CDM: Recommendation Form for Small Scale Methodologies (version 01)

<i>Date of SSC WG meeting:</i>	11 - 13 February 2008, SSC WG 14
<i>Title/Subject (give a small title or specify the subject of your submission, maximum 200 characters):</i>	Calculations of baseline emissions from wastewater systems with are partial anaerobic
<i>Indicative methodology to which your submission relates (refer the items of Appendix B of the Simplified Modalities and Procedures), if applicable.</i>	AMS III.H. version 8
<i>Name of the authors of the query:</i>	Hendrik Brinks Institution: DNV Hendrik.Brinks@dnv.com

Clarification is requested on the baseline calculations in AMS III.H version 8 in case of multiple treatment systems.

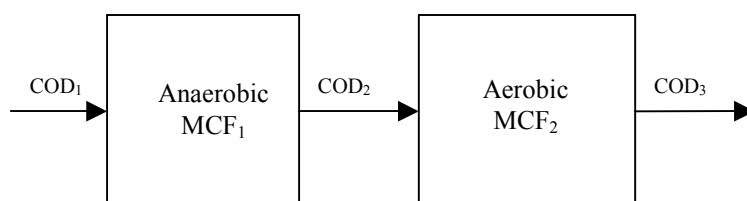
AMS III.H may be applicable to projects activities that have a baseline with partial anaerobic and partial aerobic decomposition of organic matter, e.g. scenario (iv) of the methodology. The underlying project activity, currently under validation, has several lagoons where only the first one is anaerobic, the remaining systems are aerobic.

According to AMS III.H baseline emissions are calculated as follows: $BE = Q * COD_1 * B_0 * MCF_1 * GWP_{CH_4}$. However for cases when $COD_2 > 0$ baseline emissions might be overestimated.

It is suggested to change the formula for baseline emissions for project activities belonging to scenario (iv), that recover biogas by means of a membrane over the anaerobic lagoon without significantly changing the ratio between COD_2 and COD_1 , into:

$$BE = Q * B_0 * GWP_{CH_4} * \sum_i (COD_{i+1} - COD_i) * MCF_i$$

The SSC WG agreed to clarify that in the case of sequential treatment systems involving anaerobic and aerobic systems, chemical oxygen demand (COD) removed by the anaerobic system/s shall be considered for conservative and accurate estimation of baseline emissions.

In order to clarify the application of AMS III.H to sequential treatment systems, the formulas of AMS III.H have been recommended for revision as contained in annex 3 of the fourteenth meeting report of the SSC WG (see formulas 2, 6, 17, 18 and 20). *Ex ante* baseline emissions are now based on COD removed in the anaerobic system/s, which is the difference of inflow COD and the outflow COD in these systems.
